LRN-01-254
LCR H01-002

**REQUEST FOR CHANGE TO TECHNICAL SPECIFICATIONS-
SUPPLEMENTAL INFORMATION
INCREASE IN ALLOWABLE MSIV LEAKAGE RATE AND
ELIMINATION OF MSIV SEALING SYSTEM
HOPE CREEK GENERATING STATION
FACILITY OPERATING LICENSE NPF-57
DOCKET NO. 99-354**

NRC Questions of July 12, 2001

NRC Questions from July 18, 2001 Meeting

Meteorological Data

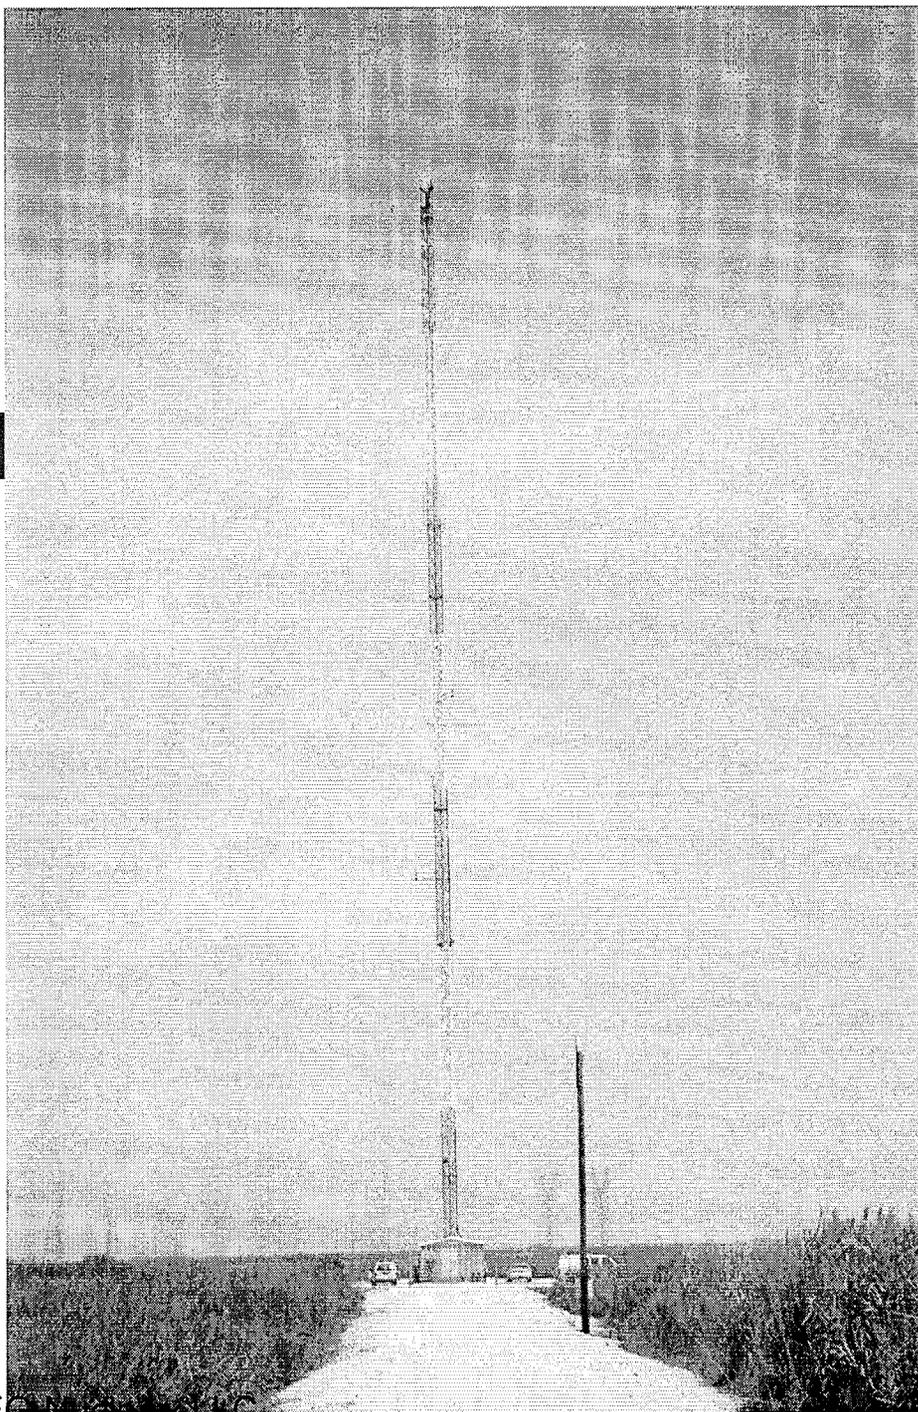
Attachment 11.2 to Attachment 5 of the submittal provides a discussion of the meteorological data used in the control room X/Q calculations. Page 2 references procedures used to QA the data. Did the measurement program also meet the guidelines of Regulatory Guide 1.23, "Onsite Meteorological Programs," including factors such as maintaining good siting, instruments within specifications, and adequate data recovery and quality assurance checks? If deviations occurred, describe such deviations from Regulatory Guide 1.23 guidance and why the data are still deemed to be adequate. What types of quality assurance checks were performed on the meteorological measurement systems prior to and during the periods of collection to assure that the data are of high quality? Were calibrations properly performed and systems found to be within guideline specifications for the use of the data? What

additional checks and at what frequency were the checks performed on the data following collection and prior to input into the atmospheric dispersion calculations to assure identifying any problems in a timely manner and flagging data of questionable quality? Were checks made to assure that any needed unit conversions were properly performed prior to using the data? Were data compared with other site historical or regional data and, if so, what were the findings? During the period of data collection, was the tower base area on the natural surface (e.g., short natural vegetation) and tower free from obstructions (e.g., trees, structures) and micro-scale influences to ensure that the data were representative of the overall site area? The intent of these questions is to assess the overall quality of the meteorological data. A detailed response for each individual data point is not expected.

The Salem/Hope Creek meteorological measurement program meets the guidelines of Regulatory Guide 1.23, "Onsite Meteorological Programs," without any deviations. Data quality is assured by collecting both analog and digital data. This data in conjunction with system calibrations, maintenance records, system surveillance records and the knowledge of an experienced meteorologist are used to validate all meteorological records. System calibration and PM's are performed on a quarterly basis and covered by approved plant procedures. Data is collected and validated using approved station procedures. During the Salem Unit 2 licensing process the meteorological data was evaluated with respect to regional data to assure its reasonableness. The meteorological monitoring site is maintained free of obstructions that could influence meteorological/ climatologically observations. Units of meteorological parameters were checked and validated. These questions were discussed at the meeting and are depicted on slides 20 thru 22.
